TOTALFLOW

Technical Bulletin 156

NGC Analytical Module (Burkert Valve arrangement) Replacement Instructions

Totalflow Technical Bulletin
Version 1.0, Revision AA (7 November 2007)

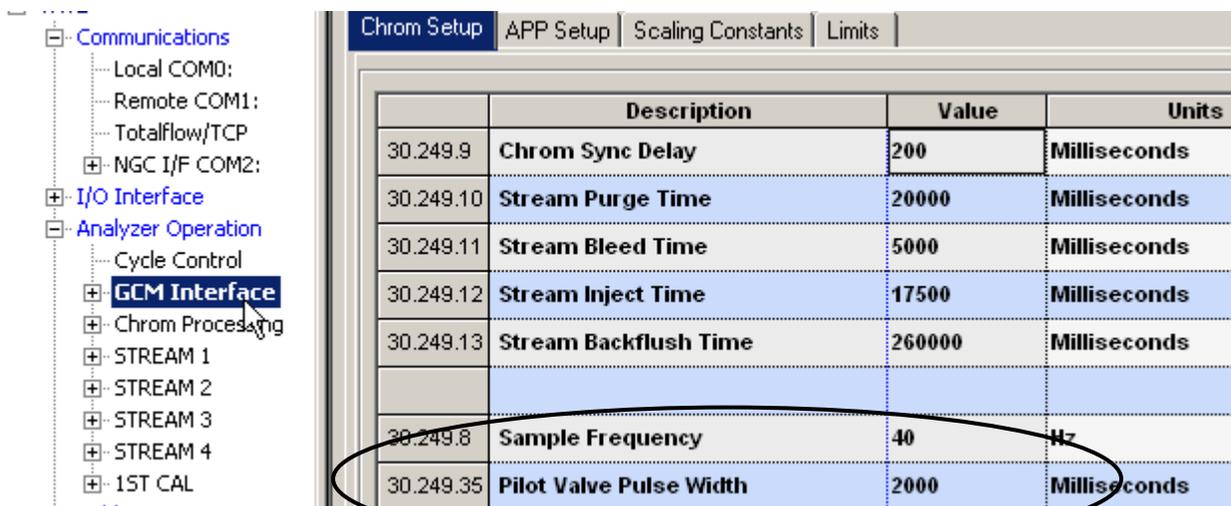
Step #10 – Changing the pulse width value using PCCUNGC software:

- a. Go to “entry mode” and select tree view mode
- b. Select “view” from the tool bar and change security to “factory” mode

- c. Select “GCM Interface” from the tree view

- d. Select the “chrom setup” tab
- e. Change the “pilot valve pulse width” from 2000 to **200** (register 30.249.35)
